AR-07-1162

Southern Nuclear Operating Company
Vogtle Early Site Permit Application
Supplemental Response to Requests for Additional Information on Geology/Seismology

Supplemental Response to Geology/Seismology RAIs

Vogtle ESP Application

Figure 1g. Quadratic fit to the amplification values for 0.5 Hz.

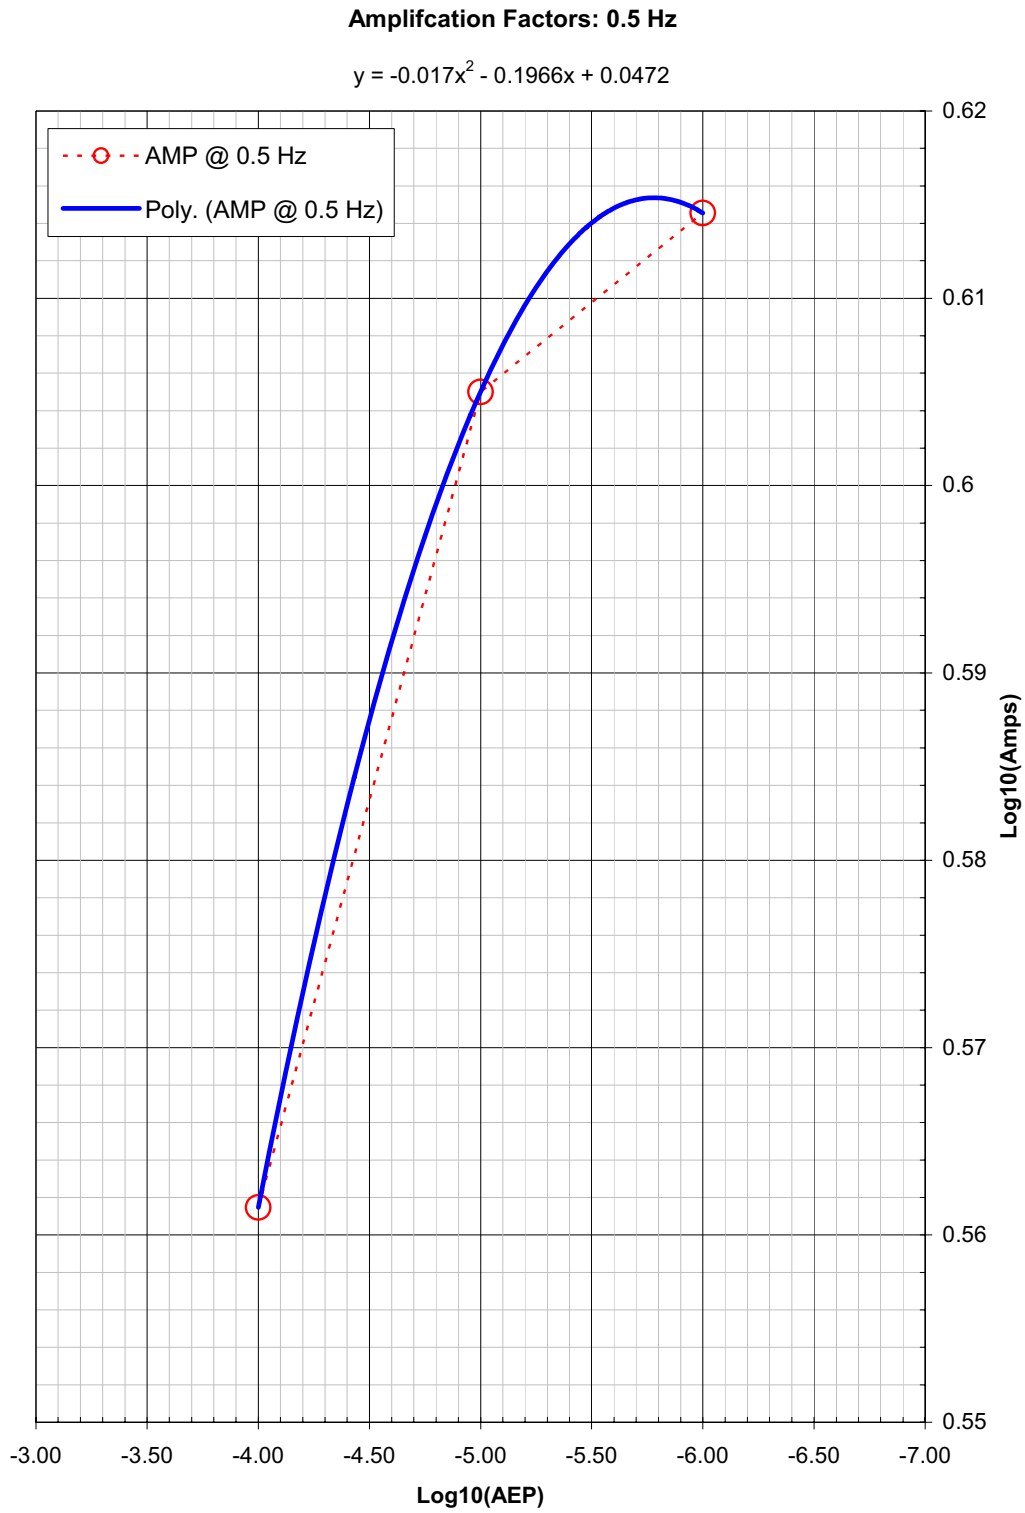
2.5.2-3 In response to this RAI, soil hazard curves were provided at three annual exceedence frequencies (10^{-4} , 10^{-5} , and 10^{-6}). However, in order for the staff to verify the adequacy of the SSE, soil hazard curves are requested at additional annual exceedence frequencies (i.e. at values between 10^{-4} , 10^{-5} , and 10^{-6}).

For each of the seven frequencies a quadratic equation was fit to the log (base10) of the spectral ratios (AMP) as a function of the log (base10) of the annual exceedence probability (AEP). Mathematically, this functional model is given as,

The resulting fits to the three data points are shown in Figure 1, located on the following pages, for each of the seven frequencies. The coefficients and equation are given at the top of each plot. Note that the red dashed line is a linear log-log line between the three data points.
